From: Price, John E [<mailto:jeprice@STPEGS.COM>]
Sent: Monday, August 08, 2011 10:09 AM
To: Tai, Tom
Cc: Thomas, Brian; Chakrabarti, Samir; Chakravorty, Manas; Head, Scott
Subject: Section 3.7 & 3.8 Actions - Updated August 5, 2011

Punch List for South Texas Project Units 3 & 4
Sections 3.7 & 3.8

**South Texas Project Units 3 & 4
Clarifications from NRC**

Issue 8: [Received 04/04/2011] (Audit Action Item 3.7-33 and 35) Stability Analysis Procedure

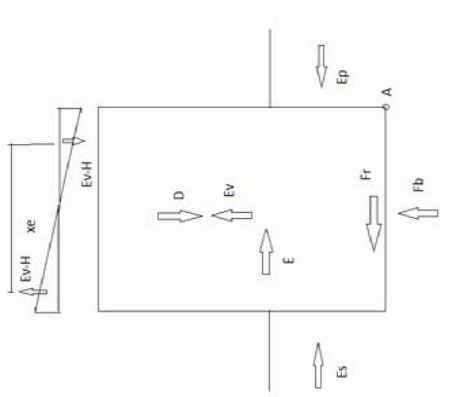
A brief presentation of the stability analysis procedure was made by the applicant during the March 14, 2011 audit. The presentation included a rigid body diagram showing the forces acting on the structure for stability calculations. The applicant indicated that the total seismic demand is calculated by summing all the inertia forces and moments acting on the structure. These inertia forces are calculated by multiplying the mass of each node by the absolute value of the maximum acceleration response at that node obtained from the SSI analysis.

The calculation of the seismic overturning moment is based on the horizontal seismic load E and vertical seismic load E_v about tipping point A , as shown in the figure below. The moment due to horizontal earthquake does not include E_v-H (vertical force due to horizontal input) which also produces overturning moment about A . The applicant is requested to provide justification for not including the vertical component of response due to horizontal seismic input in calculating the foundation overturning moment.
